## SERVICE BULLETIN

**APPLICABILITY:** 2020-21MY Legacy & Outback  
 2019-21MY Forester  
 2021MY Crosstrek

**NUMBER:** 09-80-21R

**SUBJECT:** DTC # P2682 & P26Ax\*\* / Thermo Control Valve – Design Change

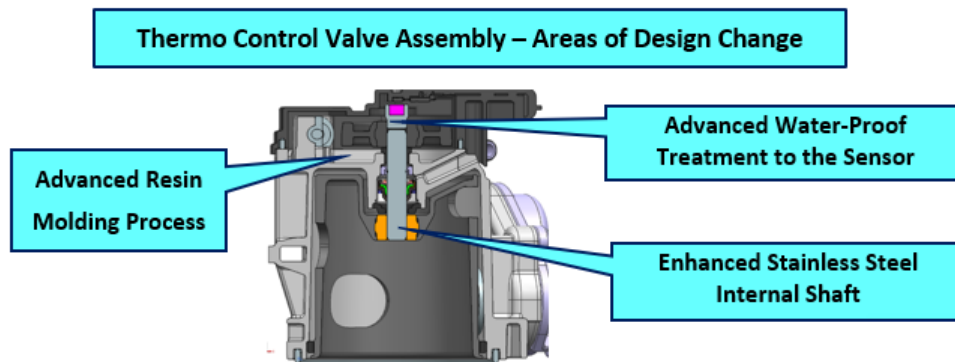
This bulletin announces availability of a new thermo control valve assembly. The new valve contains an enhanced stainless steel internal shaft for optimized durability along with advanced water proofing for the sensor portion. A new resin molding process was also used in production. These changes were implemented to prevent sensor corrosion which can cause DTCs P2682 and/or P26A\*\*.

**NOTE:** The new valve assembly comes with a replacement o-ring.

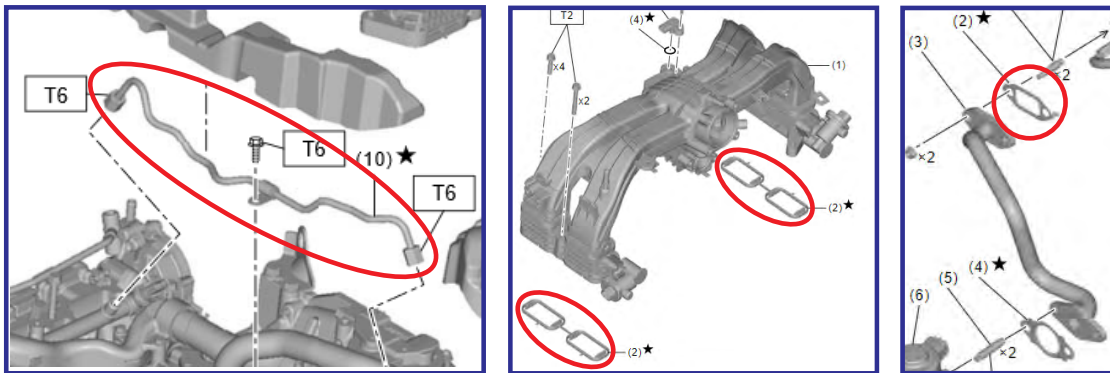
- The Service Manual uses a black star (★) in the component breakdown illustrations to indicate one-time use parts. The high-pressure fuel delivery pipe, intake manifold gaskets, and EGR cooler gaskets are one-time use parts (shown below).
